Proposal Request

PROJECT: *(name and address)*
AWSOM
Bentonville, Arkansas

PROPOSAL REQUEST 039

MSE Walls, Curbs, and Grading

1 Grading Plan - Ground Floor 2
Scale: 1/16" = 1'-0"

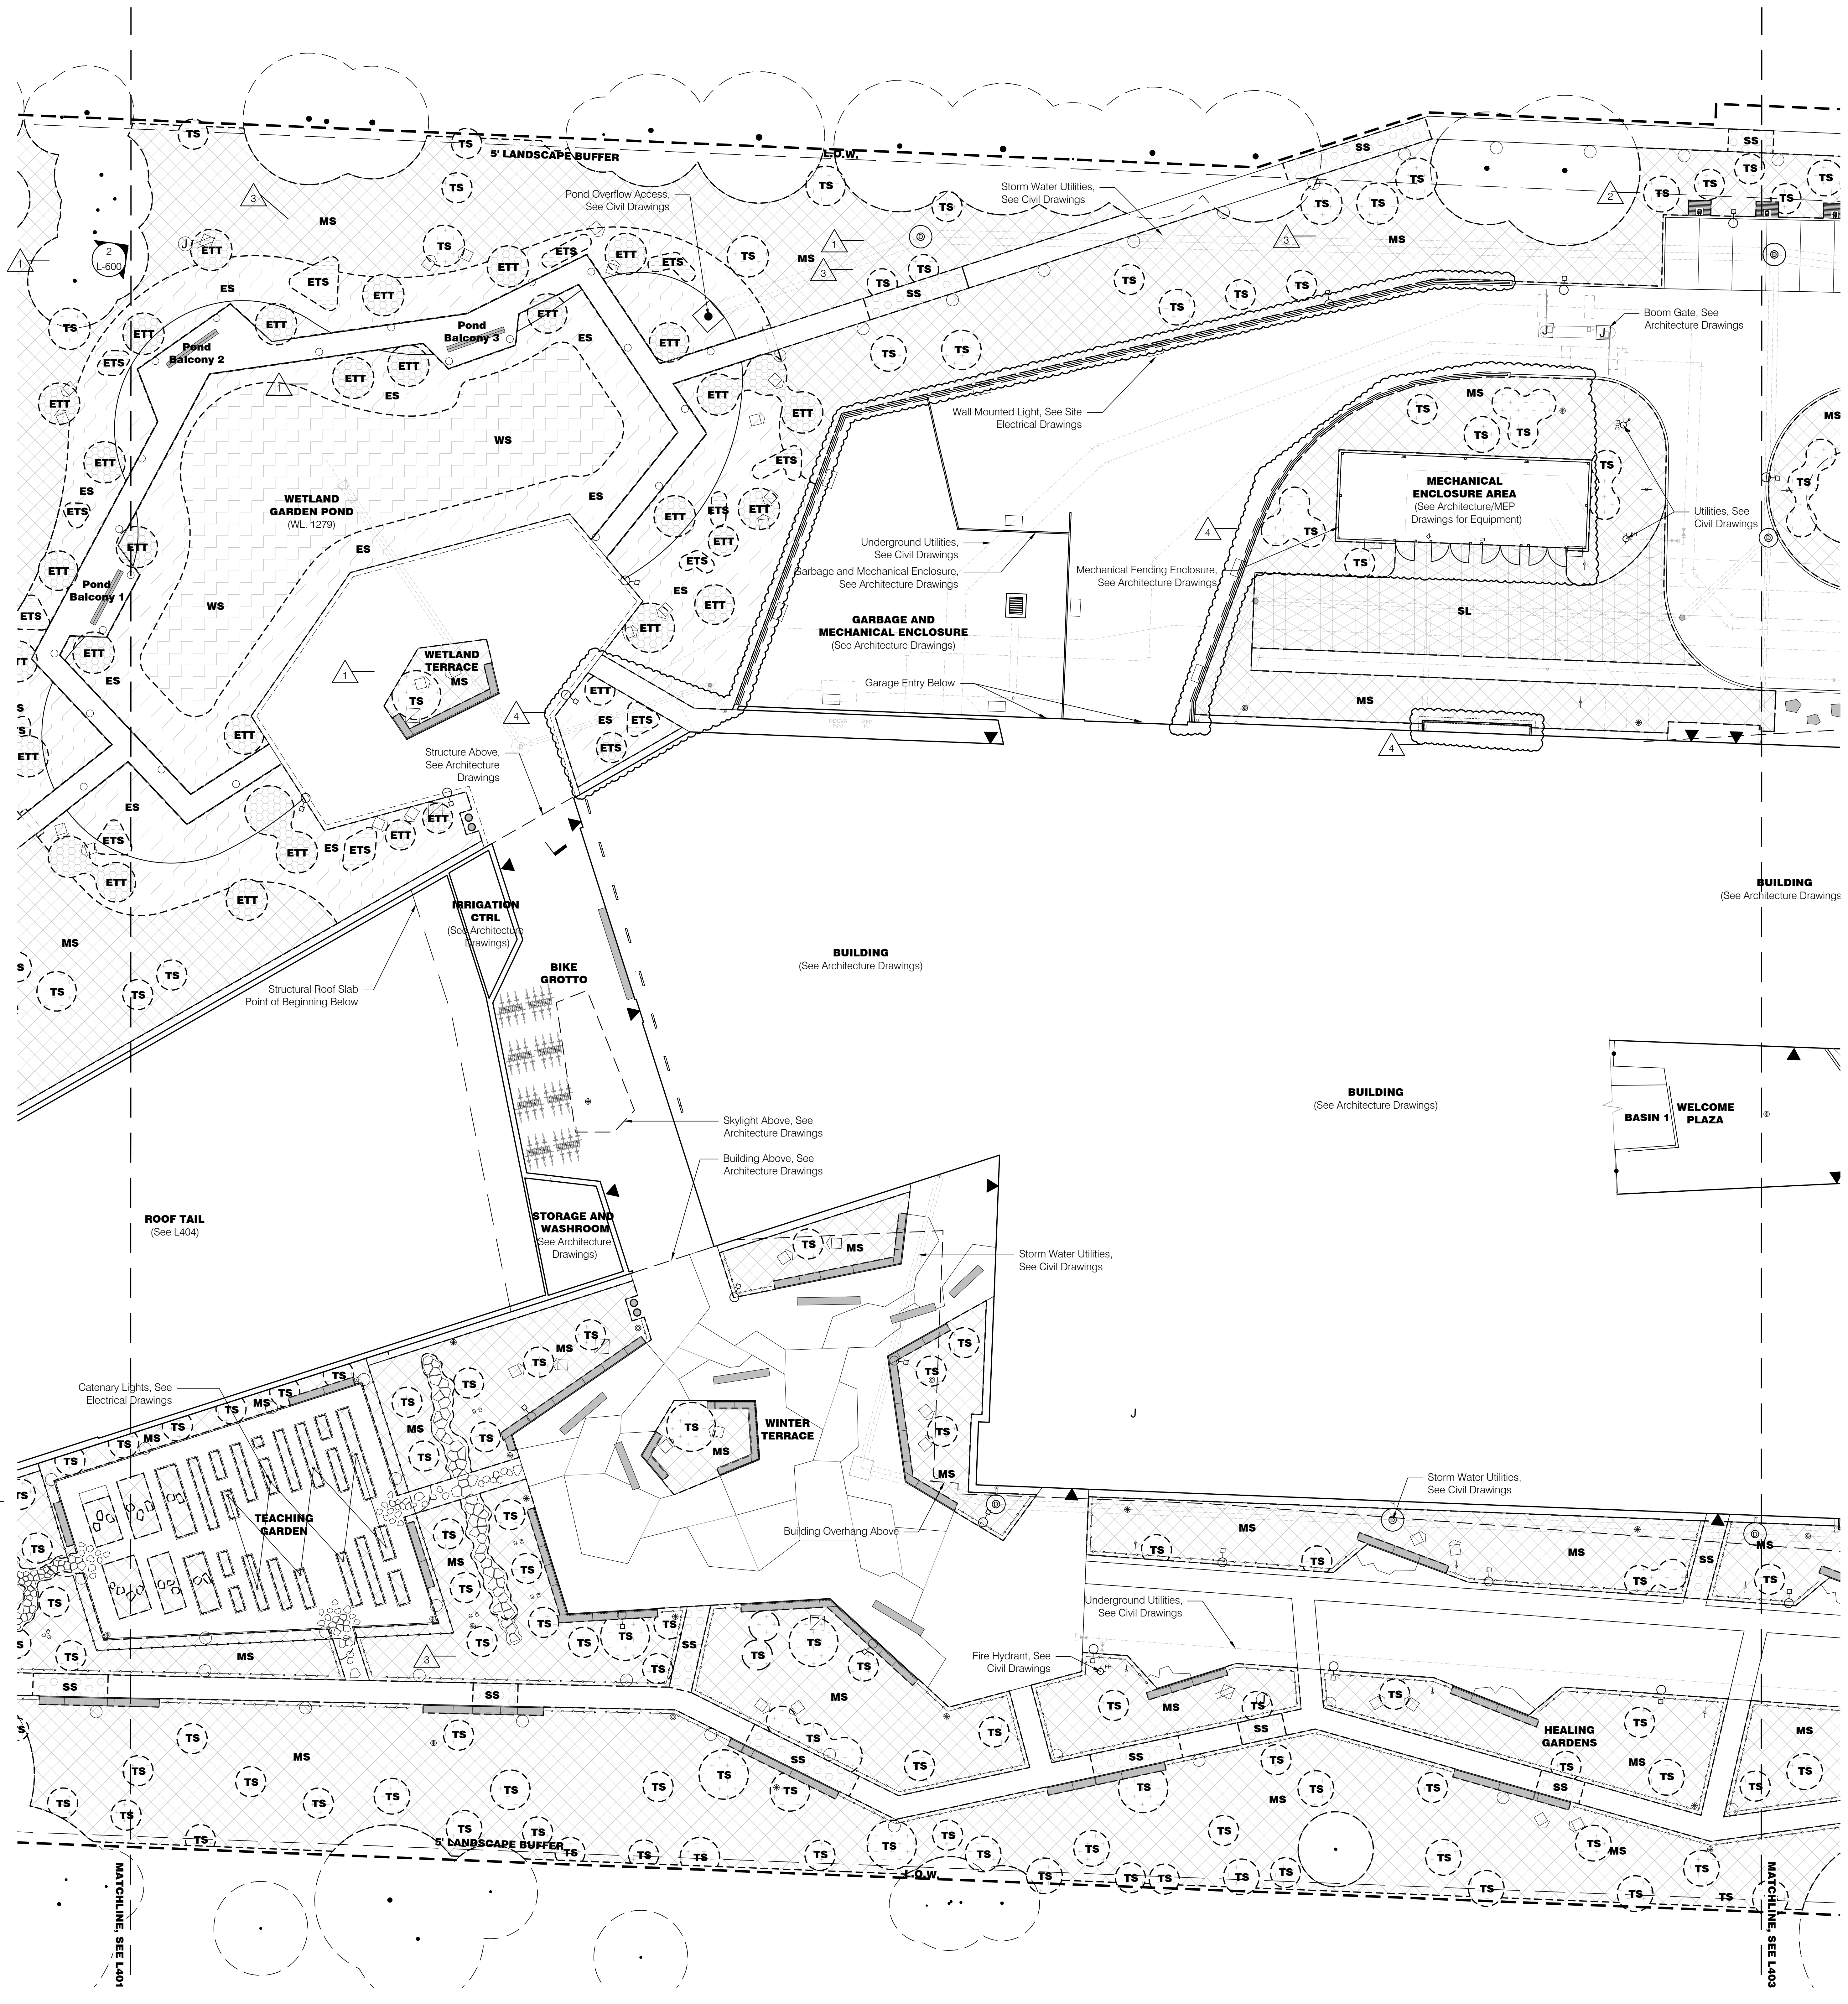
- e) Refer to Revised Sheet **L302**, with original issue date 03.13.2023 and revision date 04.04.2024.
 - Updated spot elevations on MSE walls.
 - Updated spot elevations on mechanical pad corners.

- Updated grading surrounding MSE walls.
 - Updated grading surrounding mechanical pad.
 - Updated grading at wetland terrace path connection.
 - Updated drain elevations and added drain north of mechanical enclosure.

1 Ground Floor Soils Plan 2
Scale: 1/16" = 1'-0"

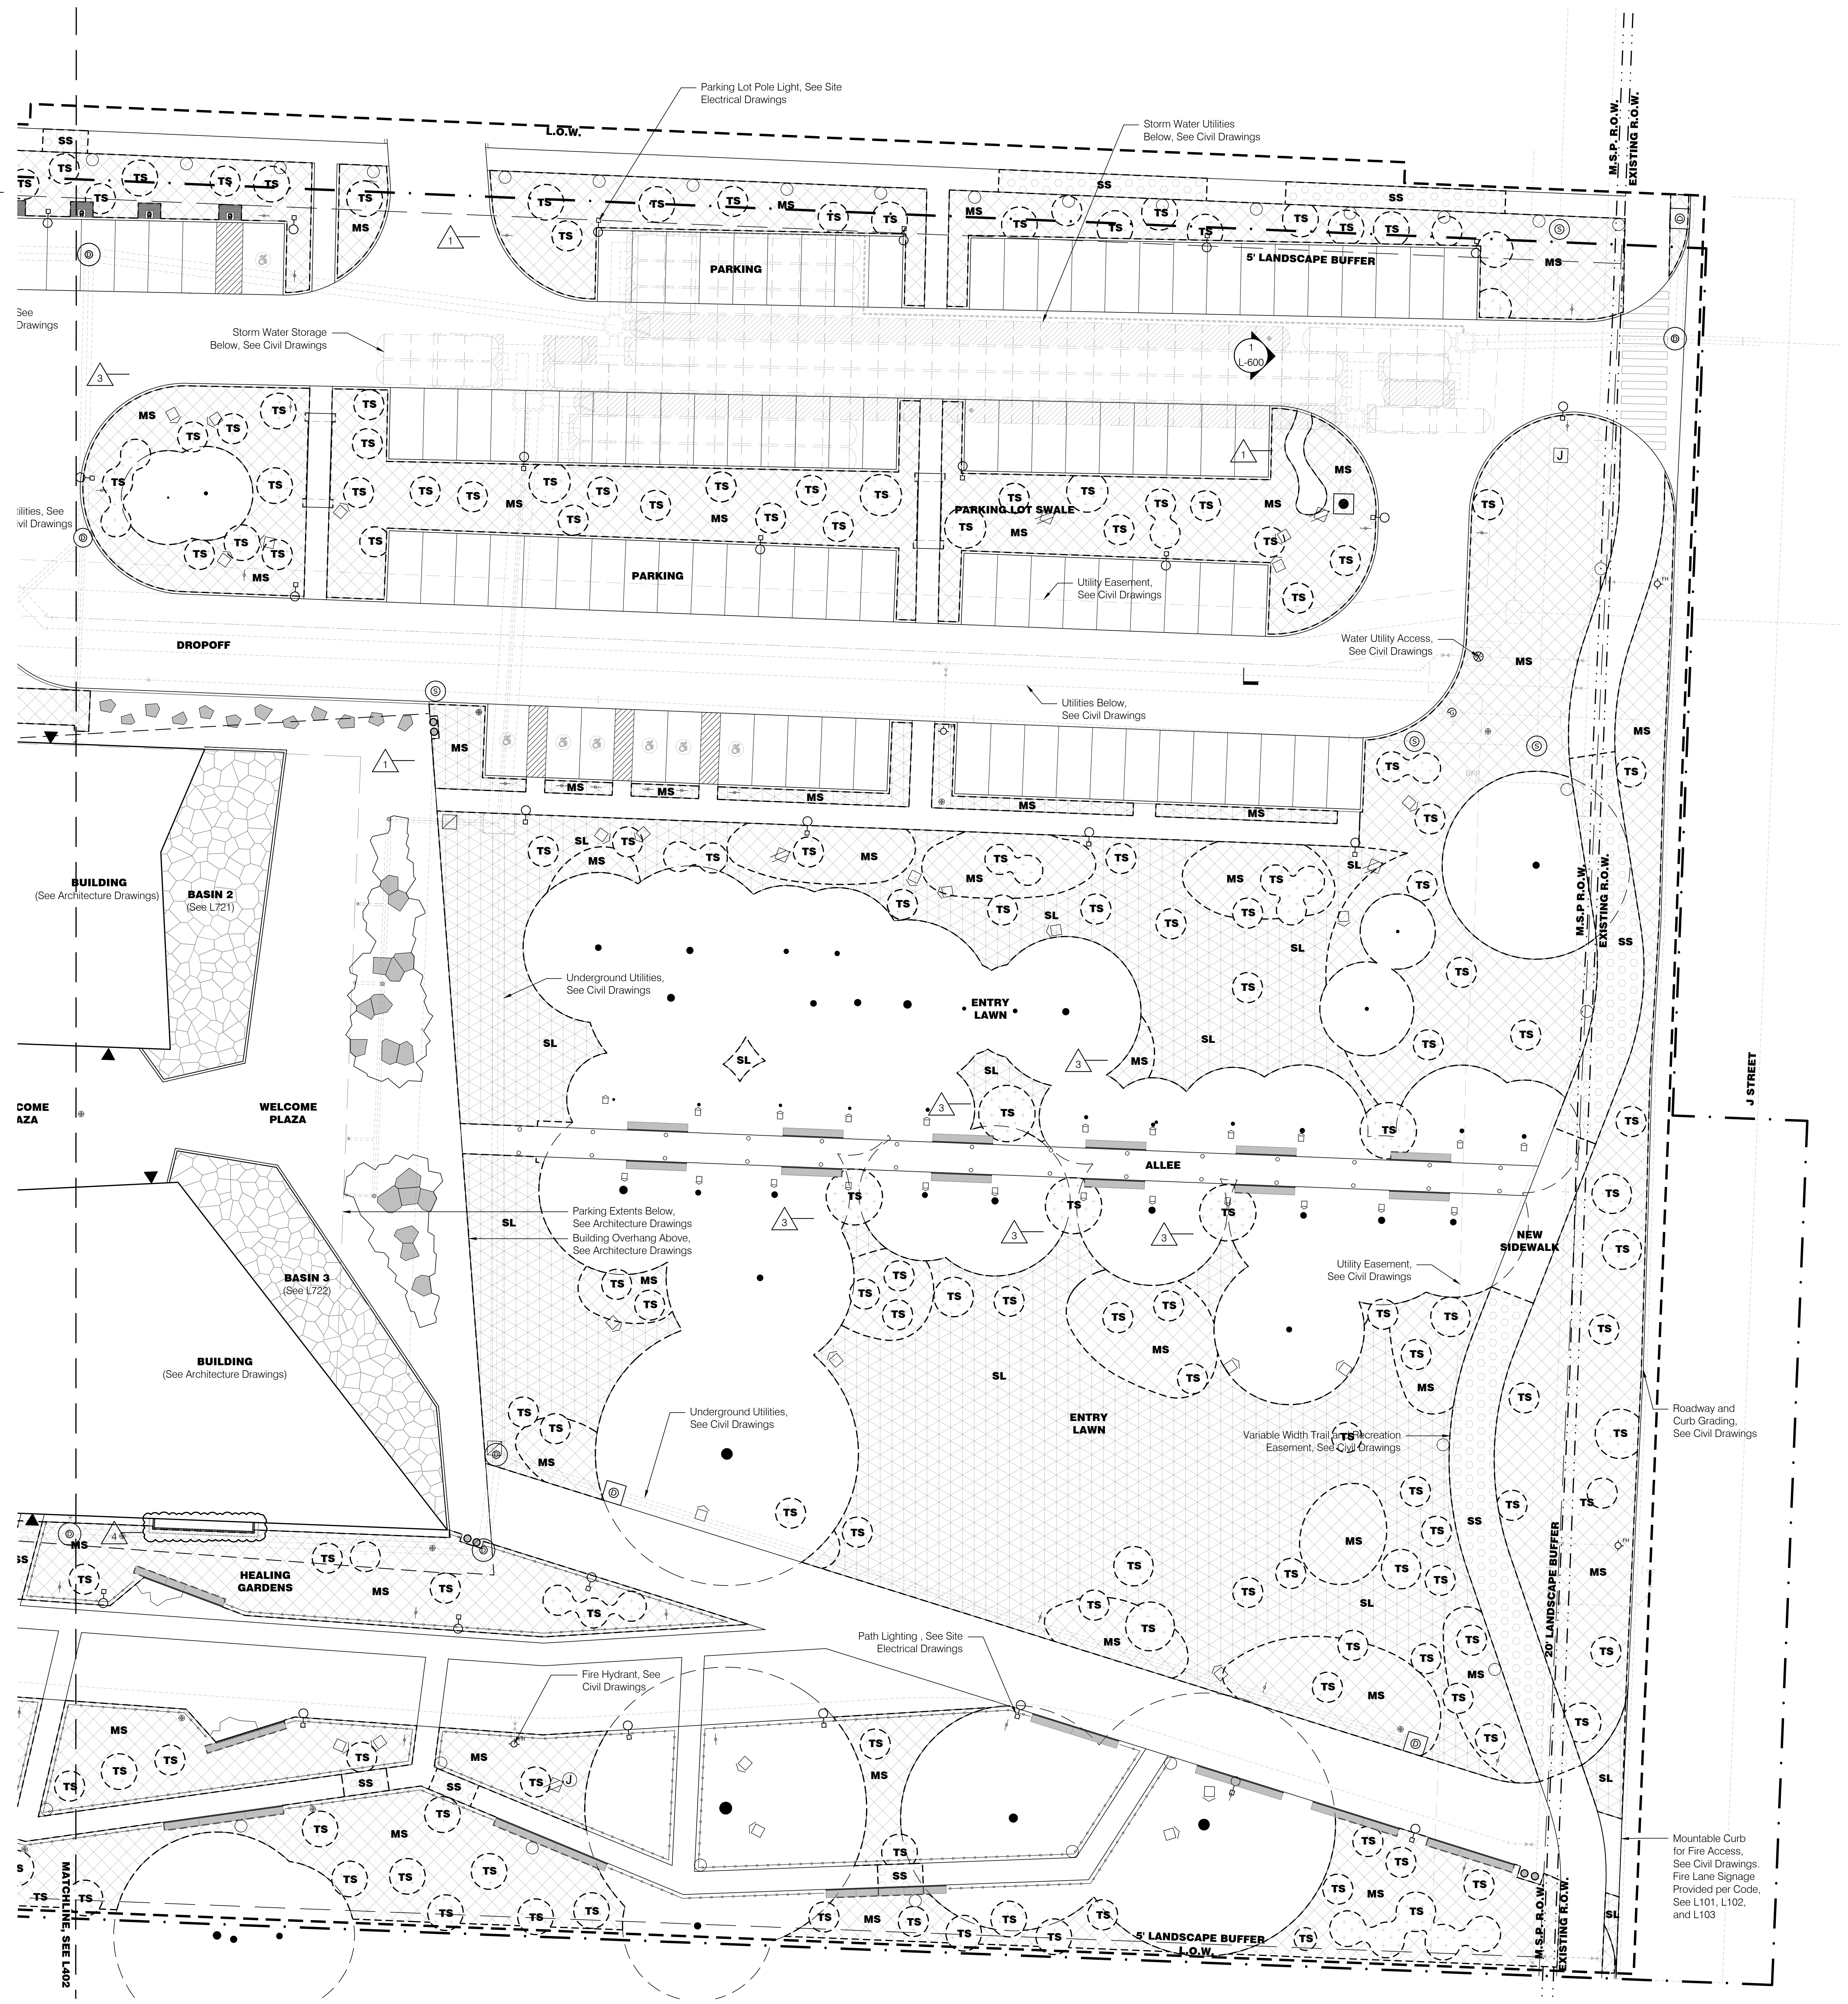
- f) Refer to Revised Sheet **L402**, with original issue date 03.13.2023 and revised date 04.04.2024.
 - Soils hatches updated along MSE wall update.
 - Soils hatches updated along updated wetland terrace path geometry.

- Updated soils hatches around mechanical enclosure.
- g) Refer to Revised Sheet **L402**, with original issue date 03.13.2023 and revised date 04.04.2024.

1 Ground Floor Soils Plan 3
Scale: 1/16" = 1'-0"

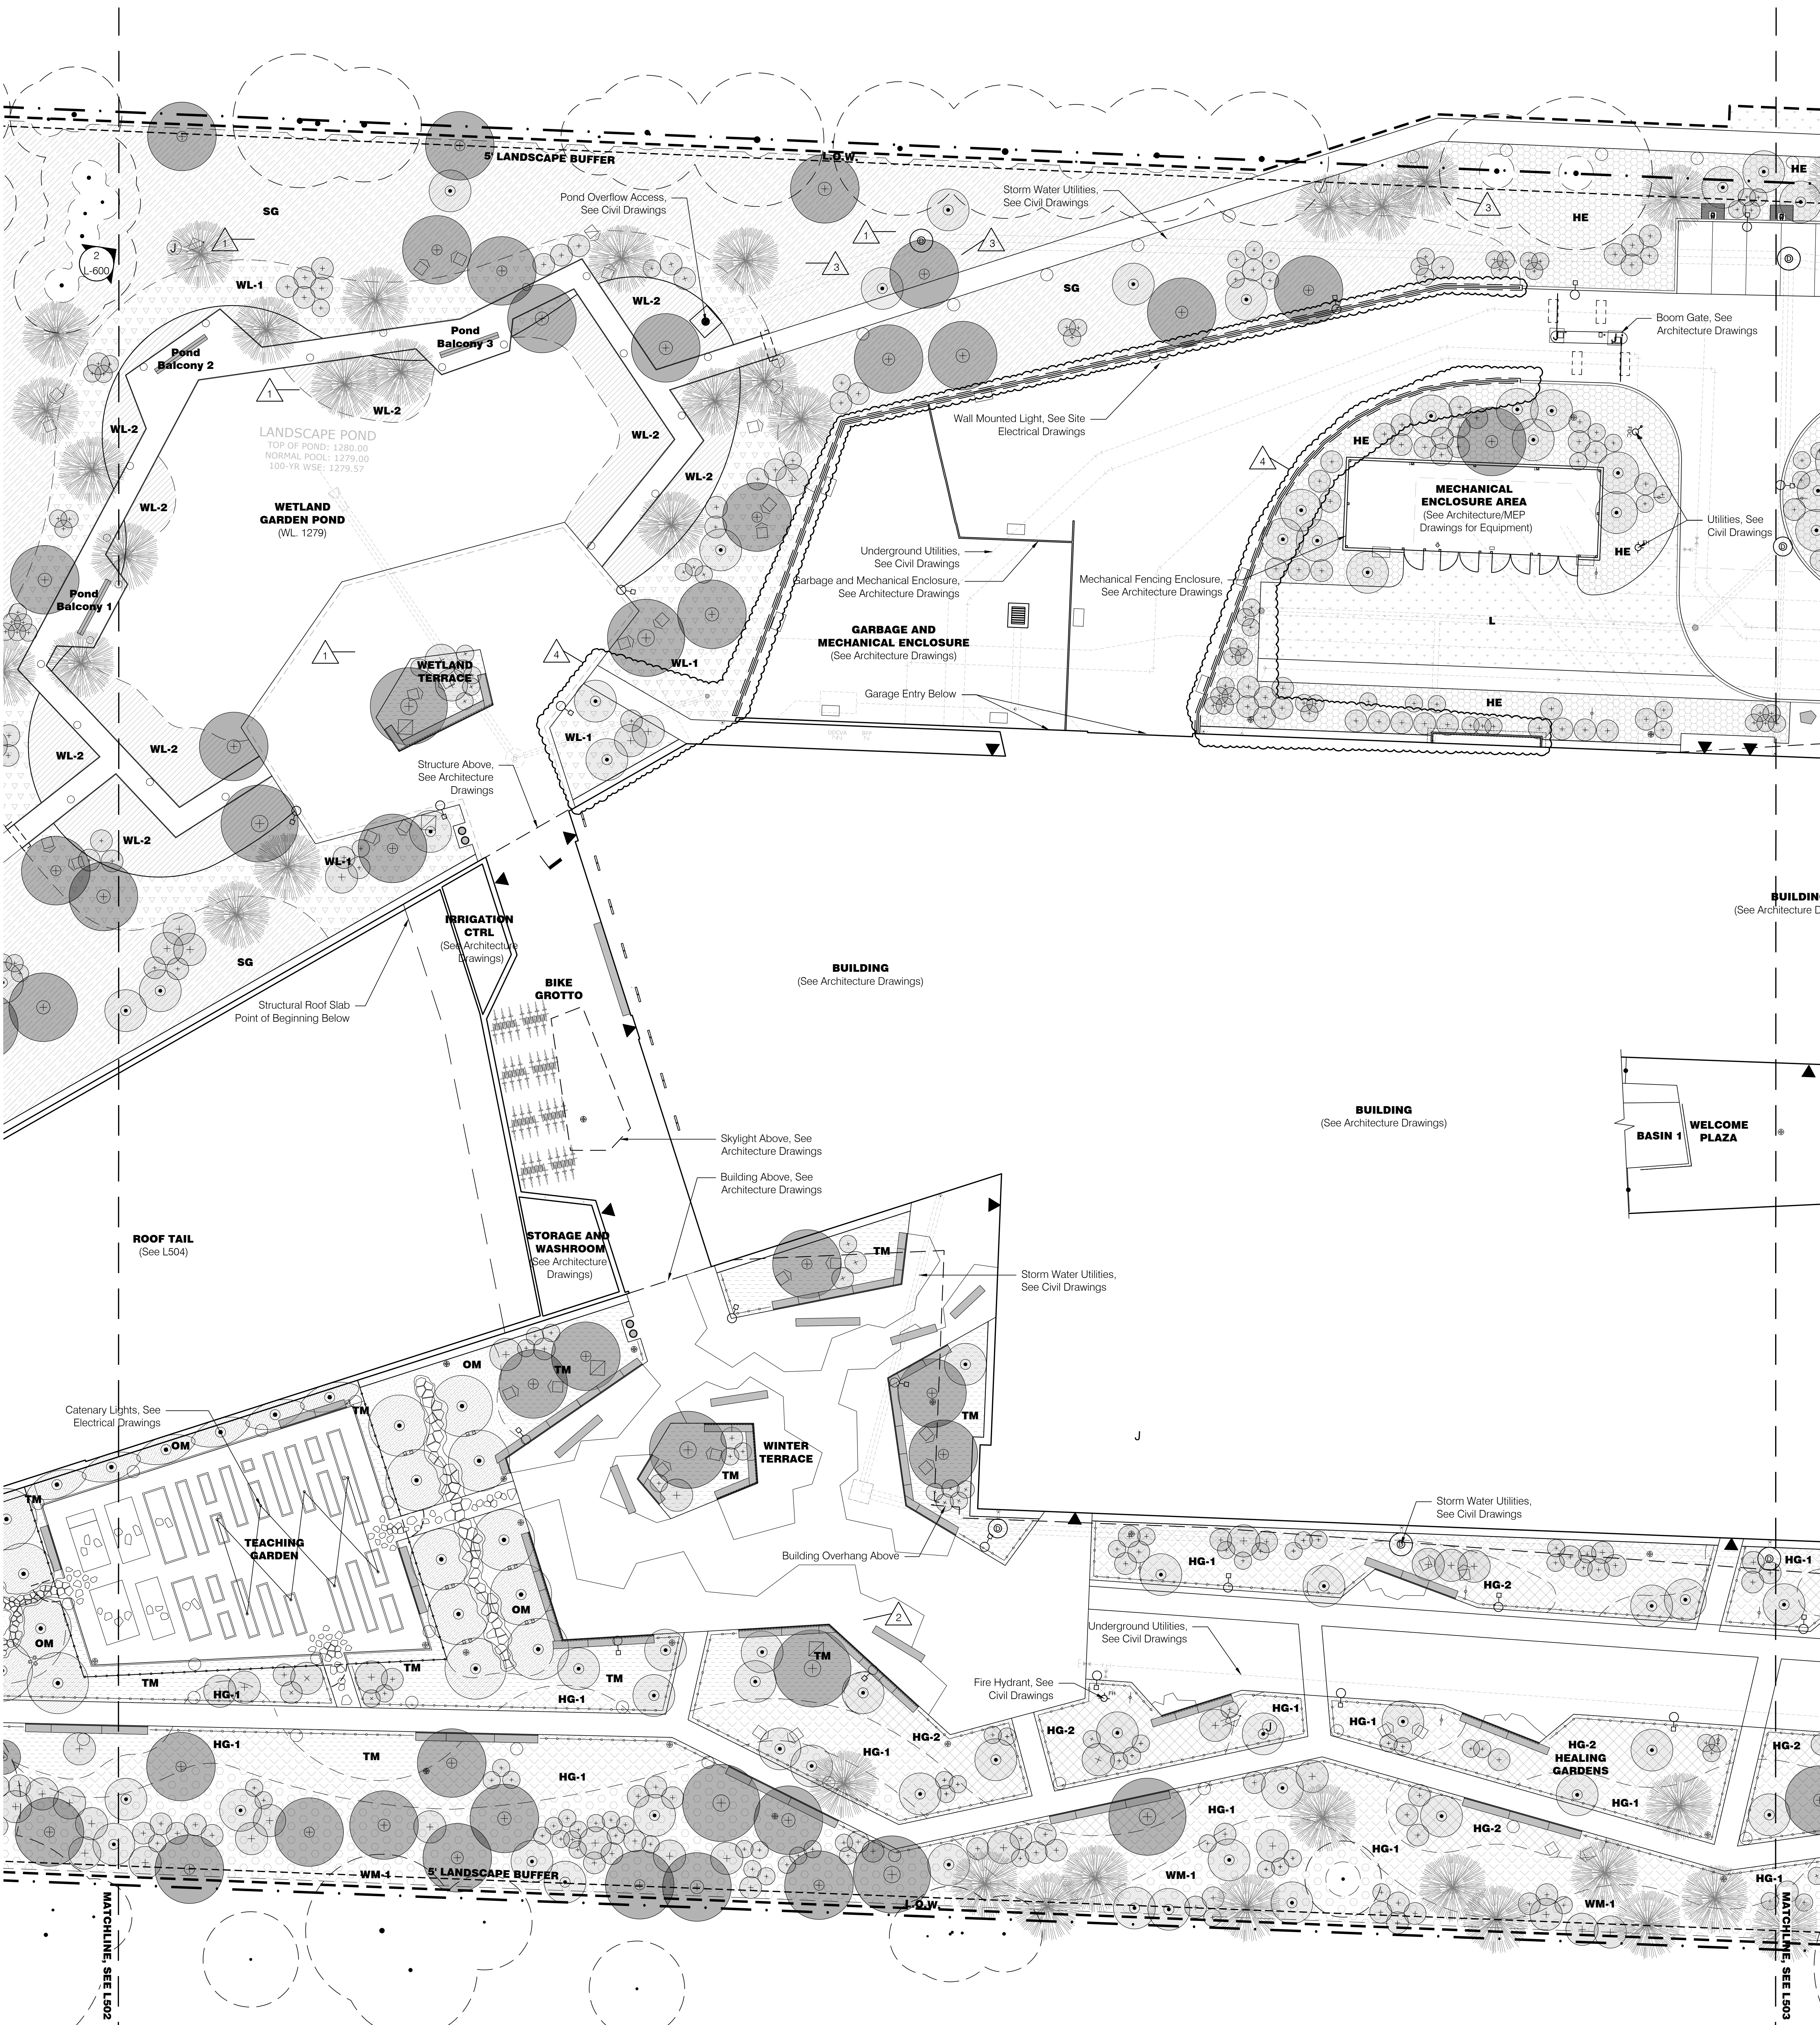
- Soils hatches updated at exhaust wells.
- h) Refer to Revised Sheet **L500C**, with original issue date 03.13.2023 and revised date 04.04.2024.
 - Updated HG-2 mix quantities.
